Well Name: HIGH HOPE FD GI	Well Location: T17S / R23E / SEC 23 / NWNE /	County or Parish/State: EDDY / NM
Well Number: 1	Type of Well: CONVENTIONAL GAS WELL	Allottee or Tribe Name:
Lease Number: NMNM0554756	Unit or CA Name: FEDERAL GI COM	Unit or CA Number: NMNM71956
US Well Number: 300152186200S1	Well Status: Producing Gas Well	Operator: EOG RESOURCES INCORPORATED

Notice of Intent

Type of Submission: Notice of Intent	Type of Action: Plug and Abandonment
Date Sundry Submitted: 09/08/2021	Time Sundry Submitted: 09:51
Date proposed operation will begin: 09/16/2021

Federal GI Com 1
30-015-21862
Lease # NM-0554756
660'FNL & 1980'FEL
Unit Letter B-23-17S-23E
Eddy County, New Mexico

Federal GI Com 1 Proposed

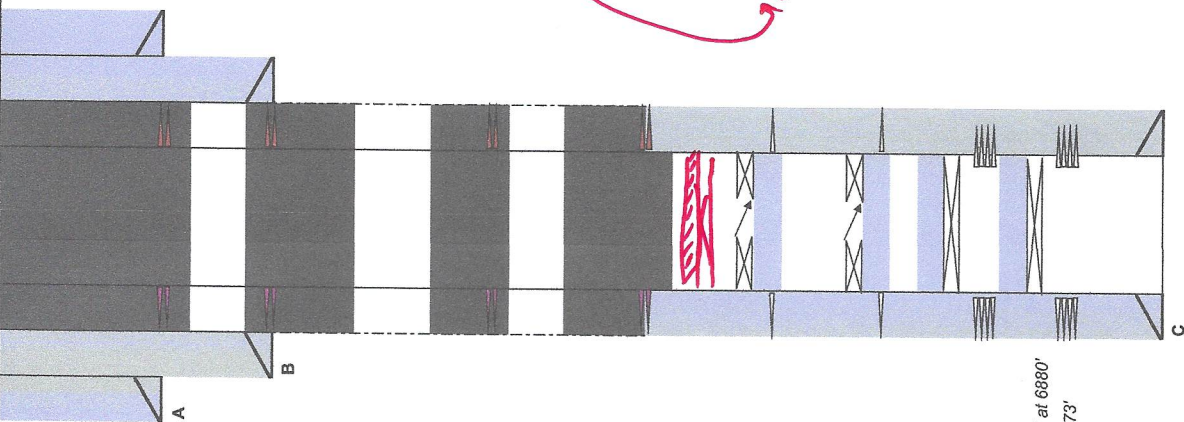
1. MIRU all safety equipment as needed. NU BOP. POOH with production equipment.
2. Perforate at 3741'. Spot a ~~45~~ ⁷⁵ sx Class C cement plug from 3741'-~~3498~~ ³⁴⁶²'. WOC and tag. This will cover TOC and Abo top. *(in/out)*
3. Perforate at 2960'. Spot a 32 sx Class C cement plug from 2960'-2830'. WOC and tag. This will cover Tubb top. *95 sx*
4. Perforate at 1602'. Spot an ~~84~~ ⁷⁵ sx Class C cement plug from 1602'-1255'. WOC and tag. This will cover Glorieta top and casing shoe. *(in/out)*
5. Perforate at 285'. Spot a ~~65~~ ⁷⁵ sx Class C cement plug from 285' up to surface. Back fill as needed. *75 sx*
6. Cut off wellhead and install dry hole marker. Clean location as per regulated. *(in/out)*

(Verify @ surface)

→ Set CSBP @ 4374' spot 25 sx class C. Leak test CSBP.

9,501 04374' 259X
